**ITEM #2 - PRELIMINARY PLAT  
KASILOF ALASKA SUBDIVISION 2023 REPLAT**

<b>KPB File No.</b>	2023.147
<b>Plat Committee Meeting:</b>	February 26, 2024
<b>Applicant / Owner:</b>	David Harry Hallstead of Kasilof & Darlene Coyle of Kasilof
<b>Surveyor:</b>	Jerry Johnson / Johnson Surveying
<b>General Location:</b>	Kalifornsky Beach / Kalifornsky APC

**STAFF REPORT**

# Kasilof, Alaska Subd. 2023 Replat Preliminary Plat

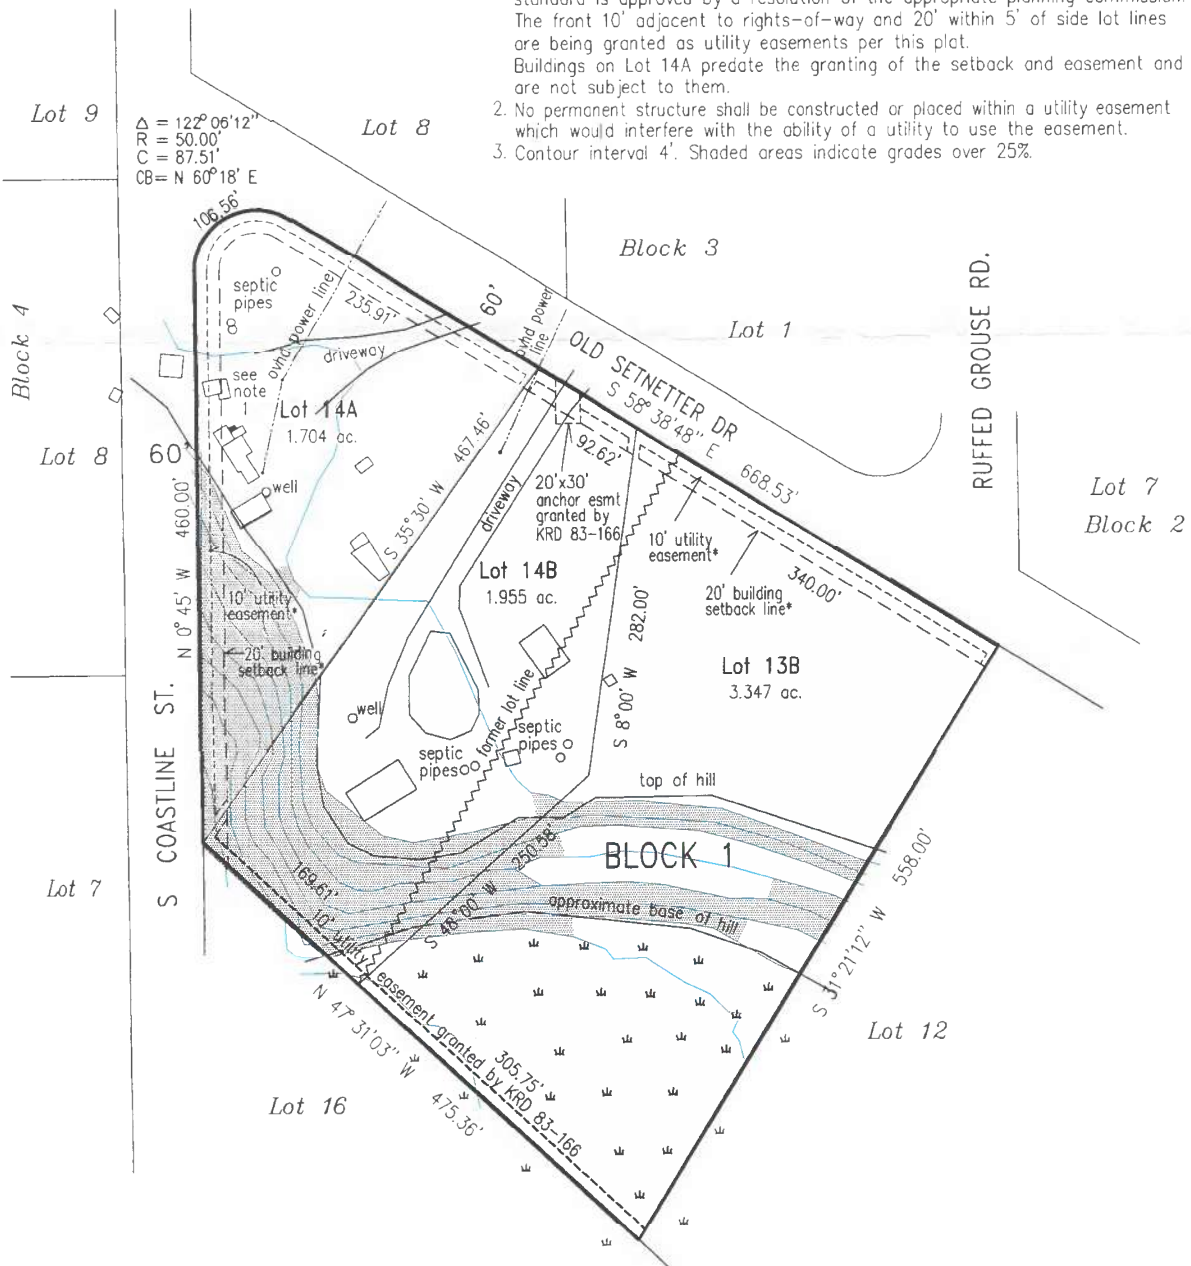
There are buildings in the 20' building setback and 10' utility easement on proposed lot 14A that predate the setback and utility easement and are therefore exempt from them as they exist now. **Staff recommends:** a sentence be added to plat note 1 to the effect as follows: any additions to the structures or new structures shall comply to the limits of the 20' setback.

There is shown a structure in the right-of-way of Coastline St S and two structures across Coastline St S in the property to the west. A solution to these encroachments needs to be submitted to staff with the first submittal of the final plat and followed through with to gain approval of the final mylar. An as-built will need submitted at that time prior to final approval. **Staff recommends:** the Committee concur these issues need resolved prior to final approval.

There are steep areas shown on the plat by the contours and shaded where greater than 20 percent. The top of hill and base of hill are labeled also. The labels and shading should remain for the final plat and the contours can be removed. Structures that do not encroach on an easement or property line should also be removed.

- Add Darlene Coyle as an owner in title block.
- Change the PO Box number for Donald H Hallstead to 1004
- Add KPB no 2023-147 to title block
- Add "Amended" to the plat name after Subd. In the legal.

Street name on the west should be Coastline St S

- Add street and names to get to the site and adjacent to.

- Add Block 1 to the lots south and west.
- Change Lot 16 to 15 on the lot to the southwest

# Kasilof, Alaska Subd. 2023 Replat Preliminary Plat

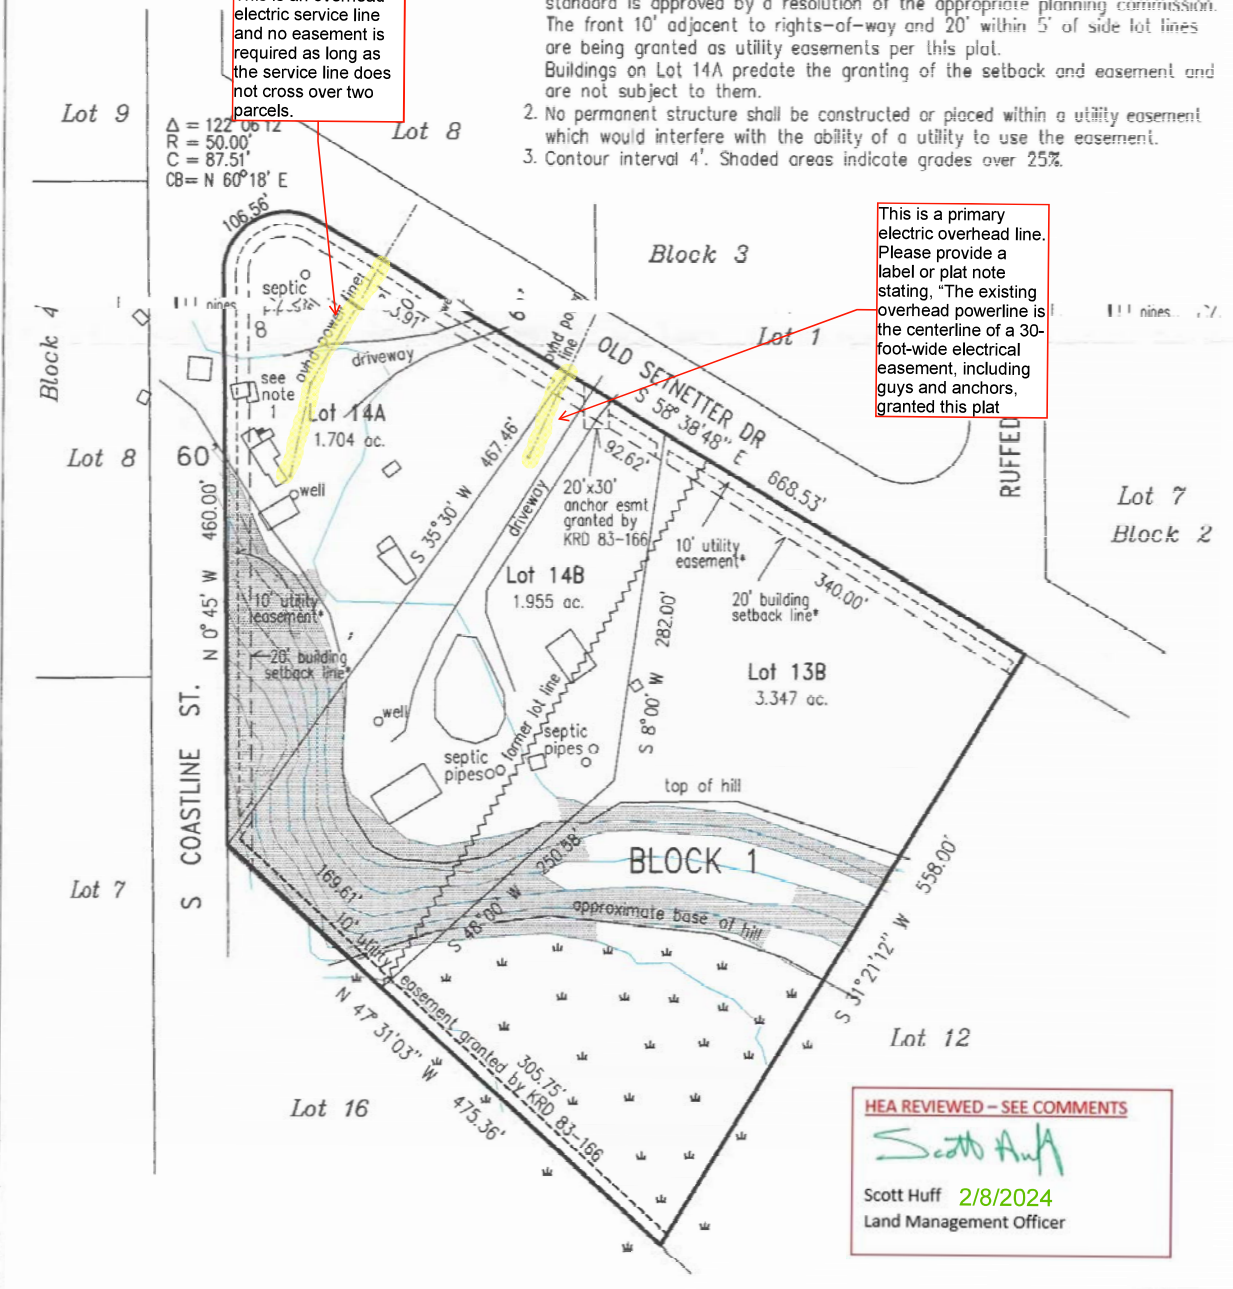
This is an overhead electric service line and no easement is required as long as the service line does not cross over two parcels.

This is a primary electric overhead line. Please provide a label or plat note stating, "The existing overhead powerline is the centerline of a 30-foot-wide electrical easement, including guys and anchors, granted this plat."
